# Certified Action of the City of Raleigh Planning Commission

**Case File / Name:** SP-25-09 / Wake Tech Health Sciences Building 2 and off-site Parking Deck

**Owner:** Wake County Technical College  
**Designer:** Kimley-Horn and Associates

**SUBJECT:** SP-25-09 / Wake Tech Health Sciences Building 2

SP-25-09 Wake Tech Health Sciences Building 2 – Site Plan

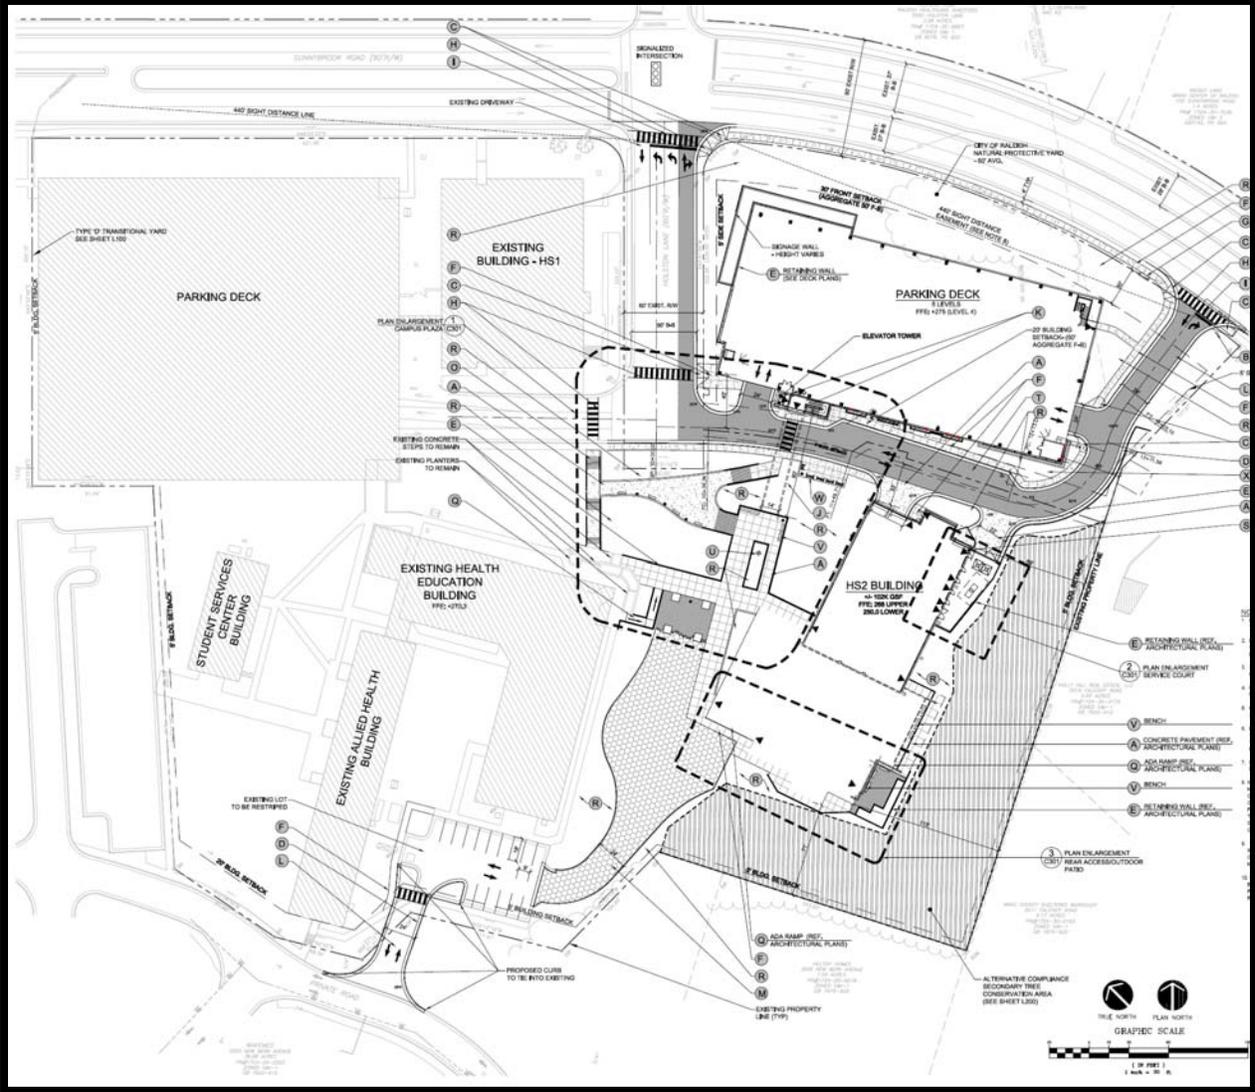
**BLOCK LAYOUT:** The proposed street layout does not conform to City Code section 10-3041 and 10-2032.2(a) and the proposed site plan does not provide for efficient circulation of traffic within the entire neighborhood area. The site plan does not meet the 1500' standard as noted in the **Streets, Sidewalks, and Driveway Access Handbook**. The applicant is seeking a variance from Chapter 3 Section 3.6 of the **Streets, Sidewalks, and Driveway Access Handbook** pursuant to Code Section 10-3004. Staff opposes the granting of this variance. See, attached letter. There are no topographic or other existing physical conditions that would cause an unusual hardship on the developer.

All other road improvements shall conform to normal City construction standards. City staff recommends a connection on this site that would connect Sunnybrook Road/Holston Lane stub street to the Wake Medical Hospital ring road network. This would be in conformance with meeting the City's standard, Chapter 3 Section 3.6 in the **Street, Sidewalks, and Driveway Access Handbook**. The specific points in conflict are:

- The roadway layout of the proposed development is not in conformity with a plan for the most advantageous development of the entire community;
- The plan fails to provide a connective street based on the City's 1,500-foot grid requirements; and,
- The plan fails to extend an existing platted public street to an adjacent property.

The proposed layout does not provide an off-site connection from the parking lot on the rear of the Wake Technical College campus to the ring road around the Wake Medical Center. Vehicular access cannot be provided from the Wake Technical College campus to this parking lot on the rear portion of the site. Under the proposed site plan, access to this parking lot would be provided from New Bern Avenue or Swinburne Street via Falstaff Road. Currently there exists on the site drive connections between Holston Lane stud and the ring road network of Wake Medical Center.

After reviewing the proposed site plan for the Wake Tech Health Sciences Project (SP-25-09), the Public Works Department is recommending denial of the plan as currently proposed. The principal point of conflict regarding the plan is the lack of interconnectivity that the plan fosters relative to the surrounding development.

- 1) The roadway layout of the proposed development is not in conformity with a plan for the most advantageous development of the entire community;
- 2) The plan fails to provide a connective street based on the City's 1,500-foot grid requirements; and,
- 3) The plan fails to extend an existing platted public street to an adjacent property.

- (2) That the Planning Commission pursuant to 10-3004 approves a variance from Chapter 3 Section 3.6 of the **Streets, Sidewalks, and Driveway Access Handbook** and approves the site plan without a connective street extension south from Holston Lane. The Commission finds that the requested connective street would not be ADA compliant and would stub into a property that currently does not provide a connection to the Wake Medical Center ring road;

- (3) That a revised site plan be submitted which shows incorporation of a north-south pedestrian and bicycle connection through the site to the adjacent Medical Center;
